TECHNICAL NOTE

PROJECT NAME	DAPPERS LANE, ANGMERING
PROJECT NUMBER	23 086
NOTE REF	TN 002
DATE	10 TH JUNE 2026
PREPARED BY	Andrew Rimmington
SUBJECT	RESPONSE TO ARUN DISTRICT COUNCIL
PLANNING REF	A/43/26/PL

This technical note has been prepared to address the comments raised by Arun District Council in their memo note of the 18th May 2026. This note has been structured to address the comments in the context of the National Standards for SuDS as issued in July 2026.

23086 - ARC - XX - XX - DR - D - 5001 - P9

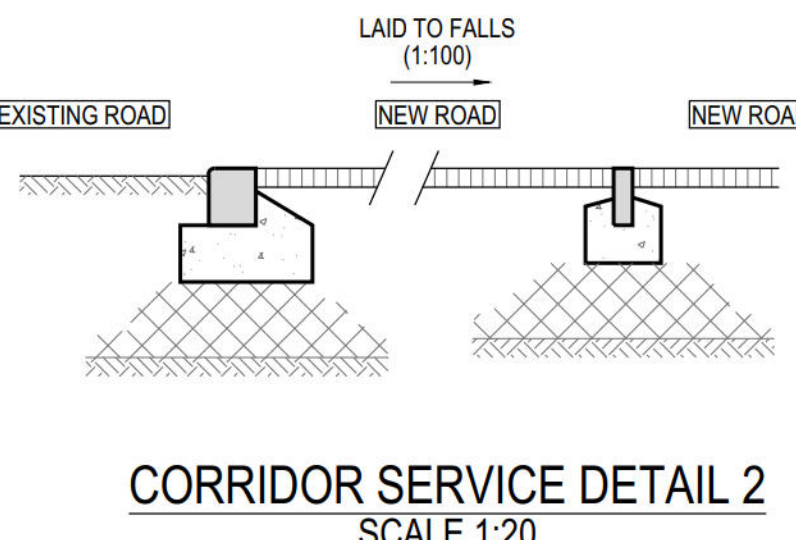
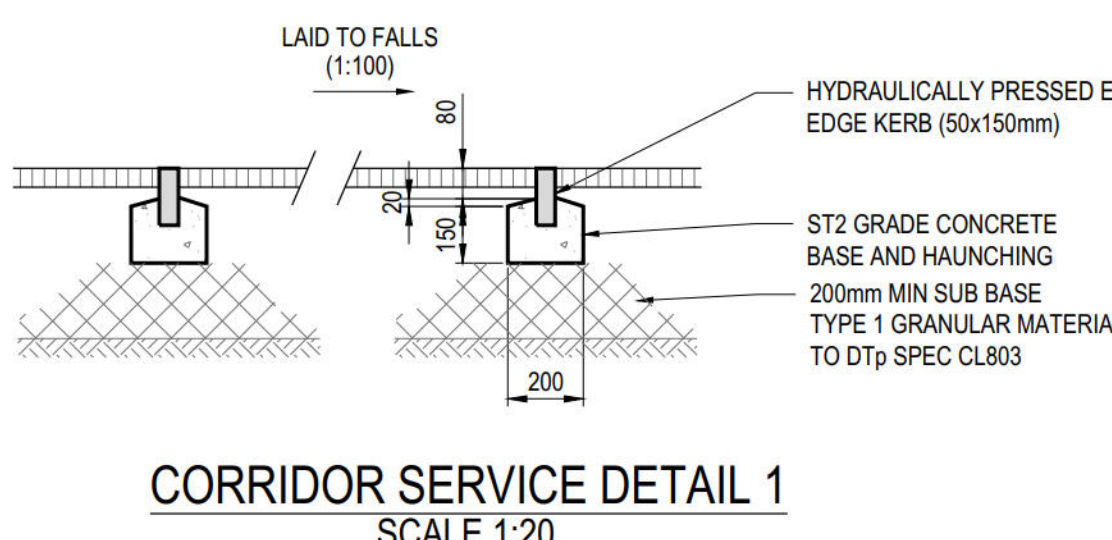
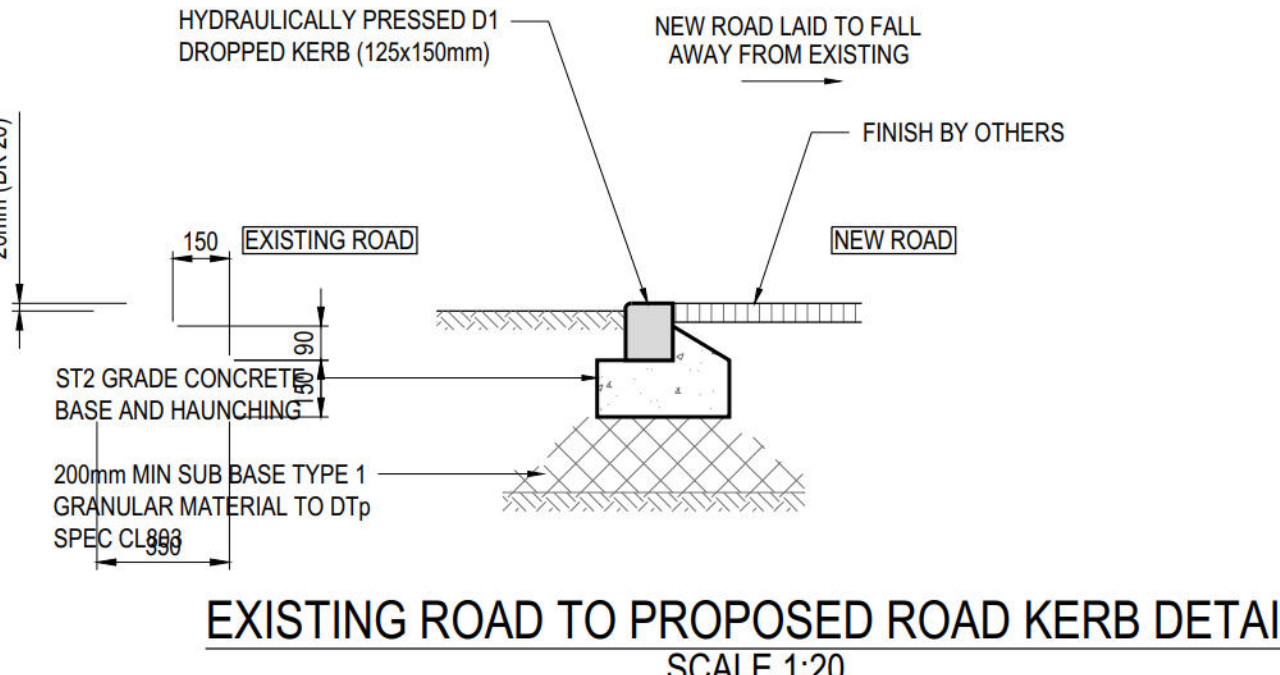
- 3.4. An impermeable service corridor route is to be provided and is shown on drawing 5001. This will shed water to the adjacent permeable area. A cross section detail has also been added to show the transition detail.
- 3.5. Root Protection Zones have been added to drawing D 5001, which corresponds with the proposed landscaping GAB24003 – 201G.
- 3.6. Permeable pavement collector drain shown in the Key on drawing D 5001 has been removed as it is not required.
- 3.7. Drawing 5001 key shows a flow control – this has been removed as it is not required.
- 3.8. A water-stop kerb detail has been added to Drawing 5001 to show the construction where the permeable pavement abuts the spine road to mitigate overland and sub-base flows?
- 3.9 Drawing 5011 with exceedance routing has been updated with additional levels and contours.

P9	UPDATED TO RECEIVED COMMENTS.	JBD	CS	AR	09.06.2026
P8	SITE LAYOUT PLAN UPDATED	SG	MG	MG	27.10.2025
P7	DRAINAGE LAYOUT UPDATED IN LINE WITH CLIENT COMMENTS	SG	MG	MG	21.10.2025
P6	DRAINAGE LAYOUT UPDATED TO SUIT REVISED SITE PLAN AND CALCS	SG	MG	MG	09.10.2025
P5	ALTERATIONS TO SUIT LLFA COMMENTS SOAKAWAY TANK 4 DIMENSIONS ALTERED. GRADIENTS OF PIPES 1.000 TO 1.003 AND 2.000 ALTERED.	JE	JE	MG	24.02.2025
P4	ALTERATIONS TO SUIT LLFA COMMENTS. PIPE REDUCED TO 600mm. CATCHPIT NOTES ADDED. RC SLAB TO TANKS ADDED. UPDATED TO SUIT DRAINAGE CALCS.	JE	JE	MG	21.11.2024
P3	EXISTING ACCESS ROAD DRAINAGE ADDED. DRAINAGE LAYOUT UPDATED TO SUIT REVISED SITE PLAN AND CALCS.	JE	JE	AR	05.07.2024
P2	ALTERATIONS TO SUIT LLFA COMMENTS	PJH	JE	AR	25.01.2024
C1	UPDATED TO DESIGN	PJH	JE	AR	20.12.2023
P1	INITIAL ISSUE				
REV	DETAIL	BY	CHK	APP	DATE

DRAWN	DATE	CHECKED	DATE	APPROVED	DATE
SG	09.10.2025	MG	09.10.2025	MG	09.10.2025
CONTRACT NO:	23086				
PROJECT NO.	ORIGINATOR	ZONE	LEVEL	TYPE	DISCIPLINE NUMBER
23086	ARC	XX	XX	DR	D - 5010 - P4

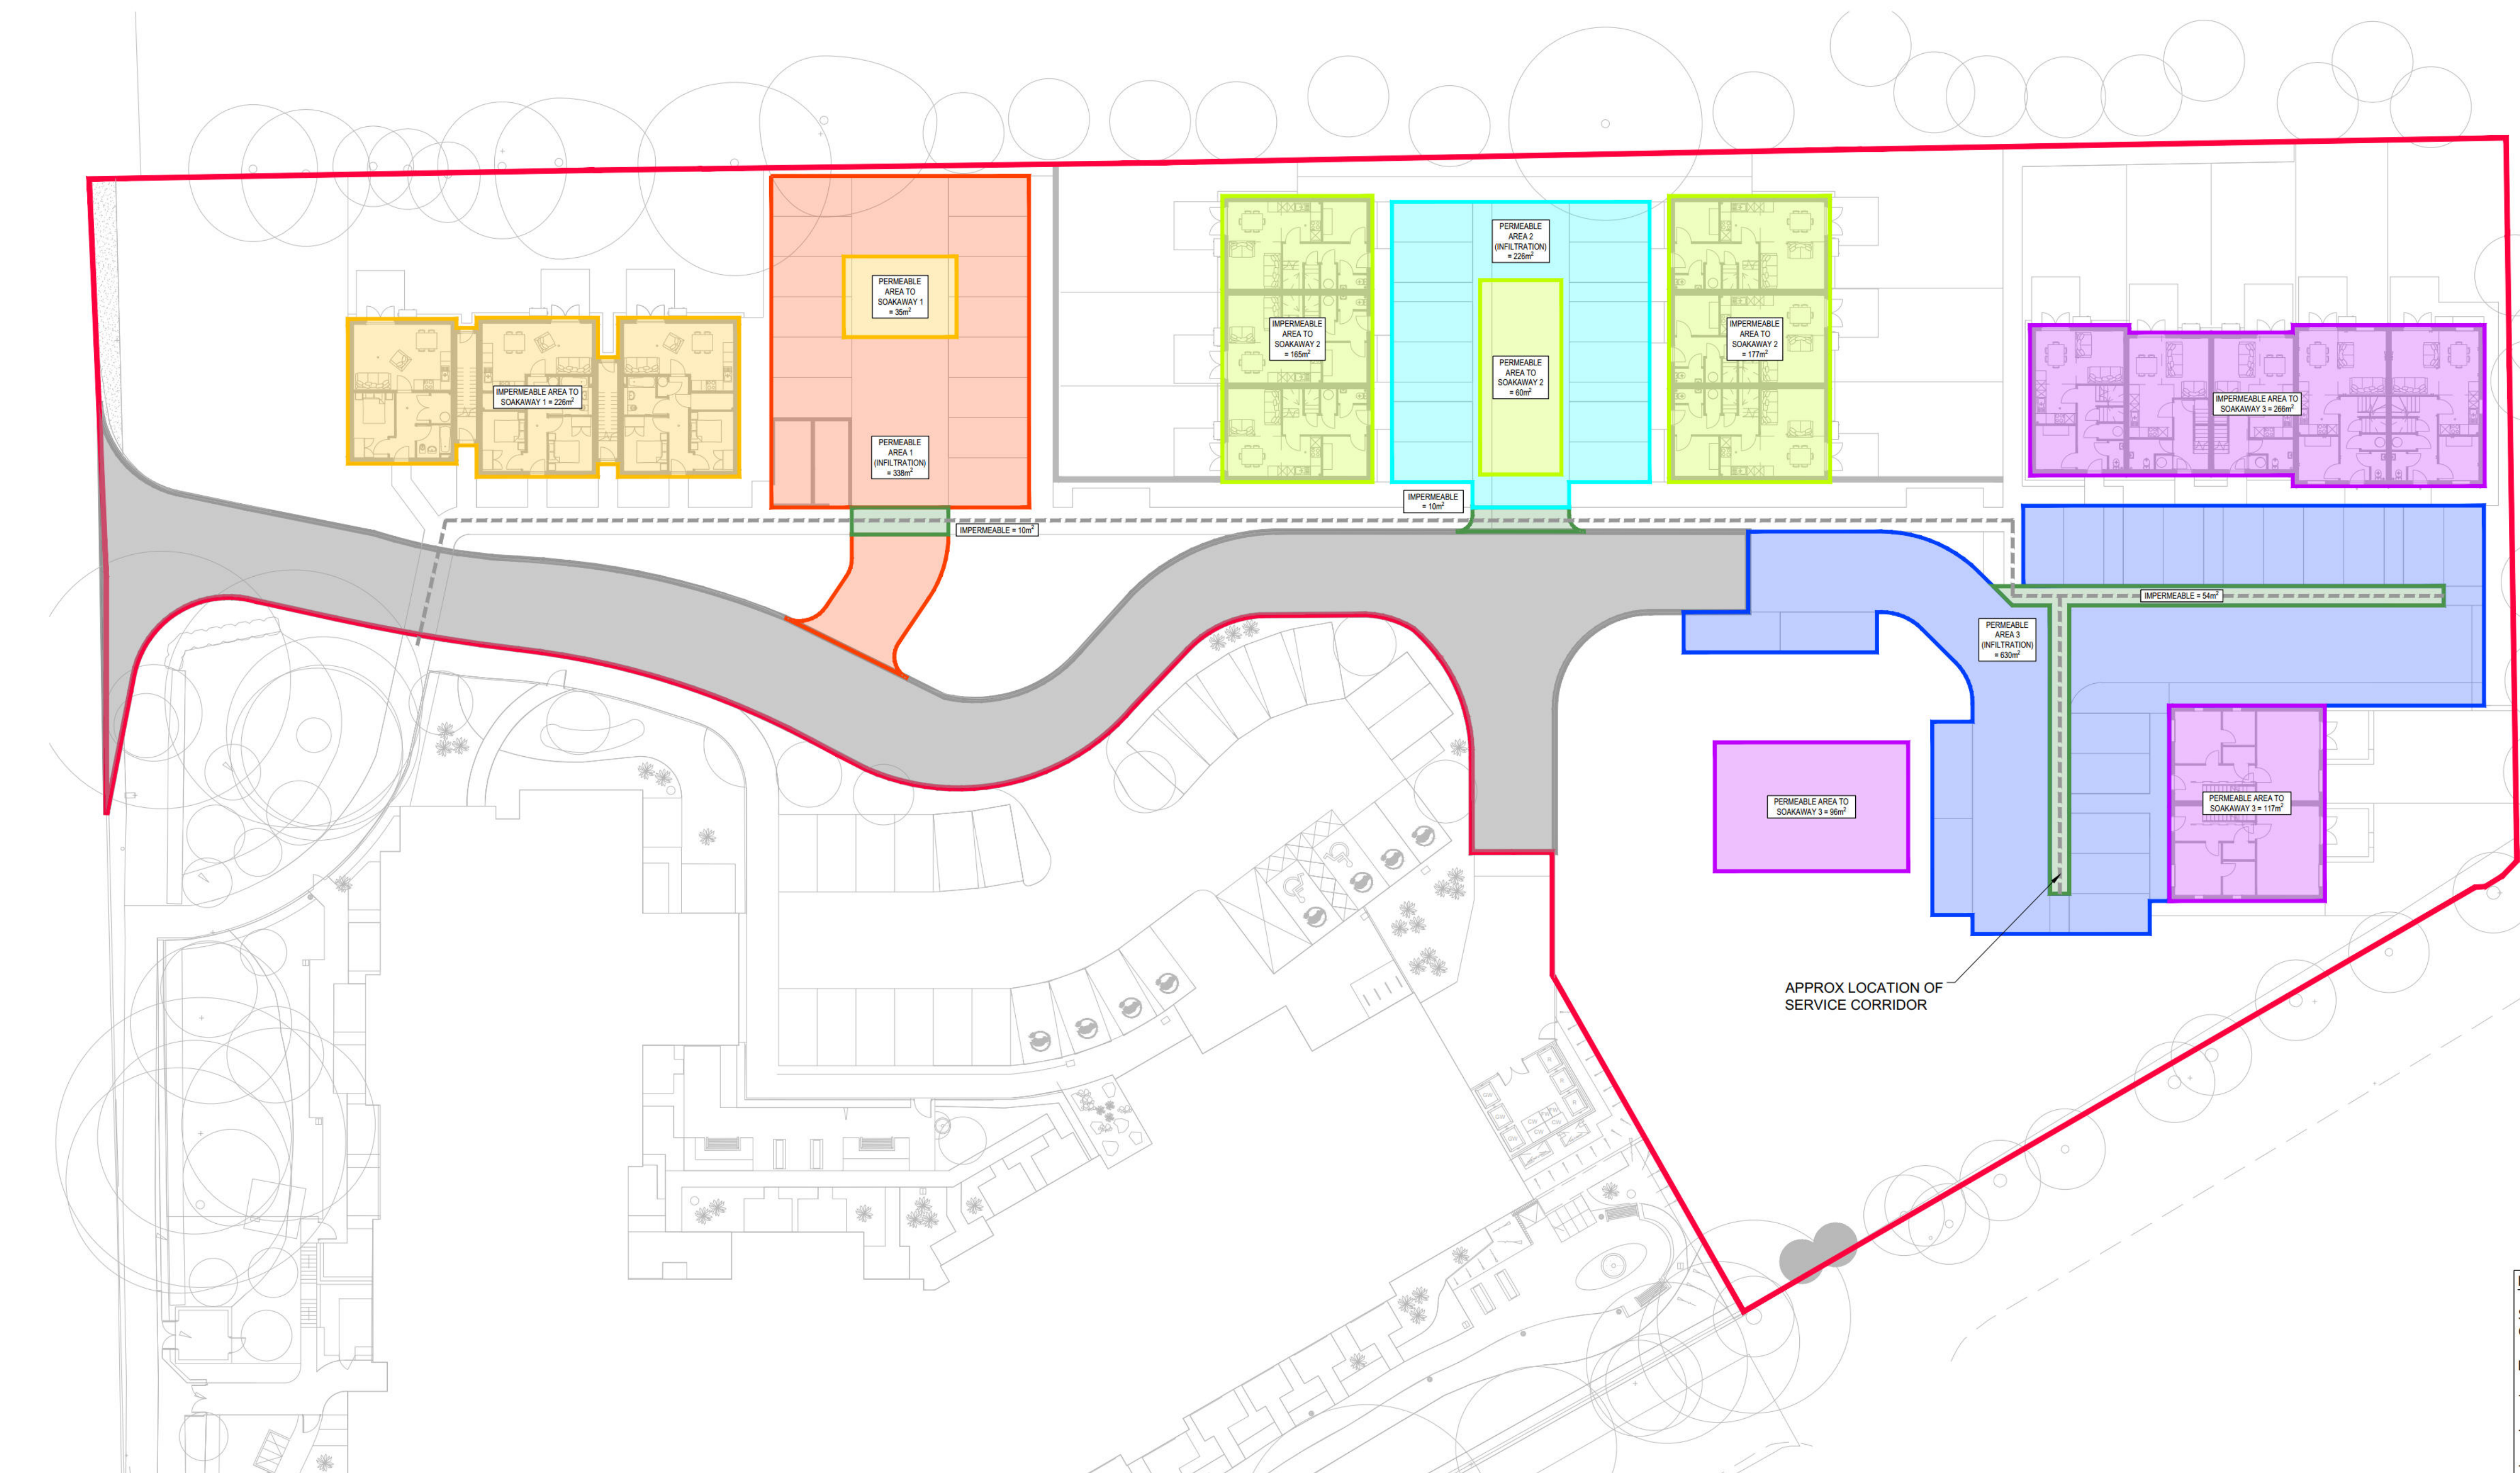
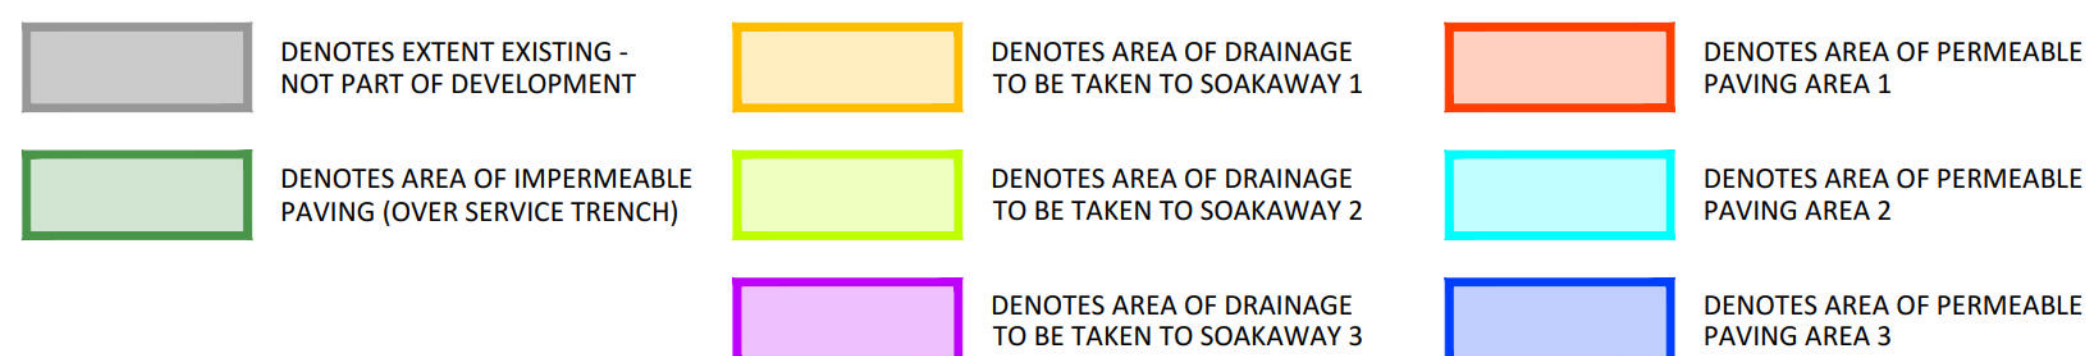
- 3.1. Calculations are provided in **Appendix A** for all areas including the permeable pavement design.
- 3.2. All calculations demonstrate the 50% half drain down time lies within 24hrs for the 30yr event.
- 3.3. Drawing 5010 has been amended to shown the overall, total impermeable area including the permeable paved areas.

REV	DETAIL	BY	CHK	APP	DATE
P4	UPDATED TO RECEIVED COMMENTS. DRAWING TITLE AMENDED	CS	AR	AR	09.06.26
P3	SITE LAYOUT PLAN UPDATED	SG	MG	MG	27.10.25
P2	IMPERMEABLE AREA REVISED IN LINE WITH UPDATED DRAINAGE LAYOUT PLAN	SG	MG	MG	21.10.25
P1	INITIAL ISSUE	SG	MG	MG	09.10.25
